# PLANNING CLEARANCE

GRAND JUNCTION COMMUNITY DEVELOPMENT DEPARTMENT

BLDG ADDRESS 2535 Hall

DESCRIPTION OF WORK AND INTENDED USE: Wood Frame Carport

TAD Coit  
2535 Hall Ave

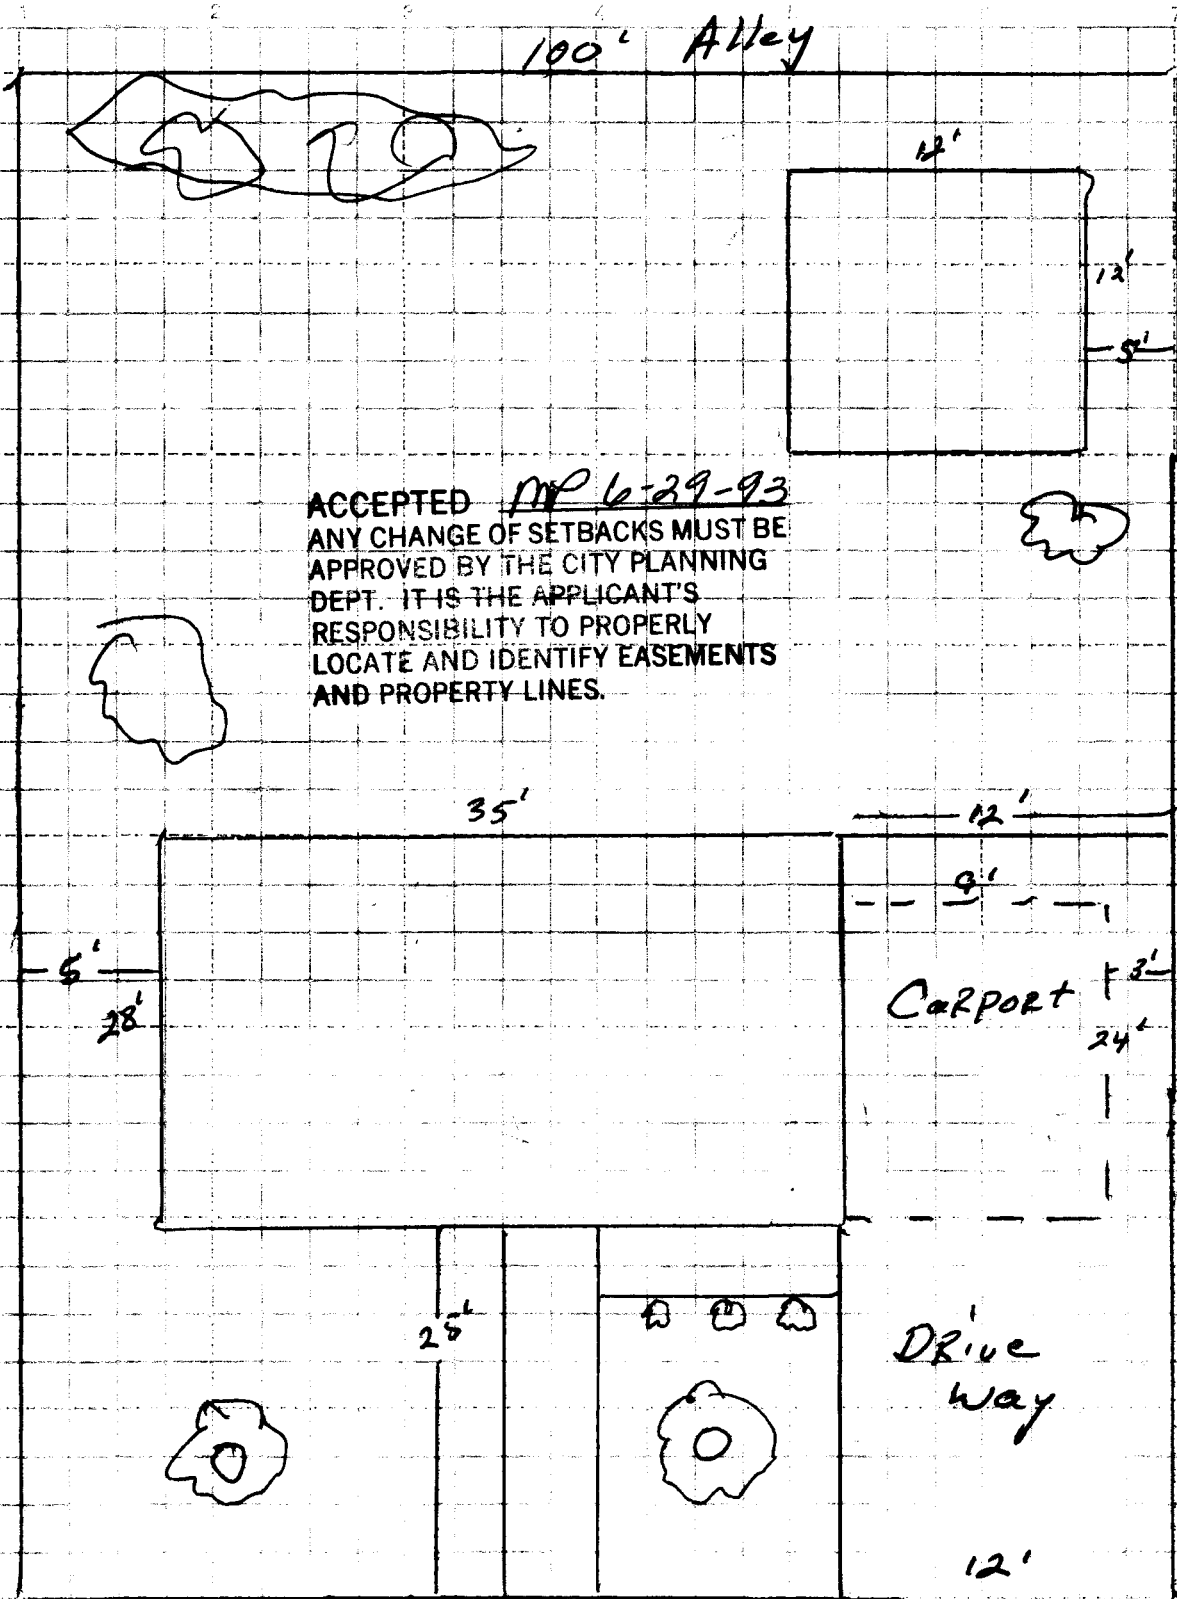
SPECIAL CONDITIONS: 3' OK for open carport (this encroaches 2' into setbacks)
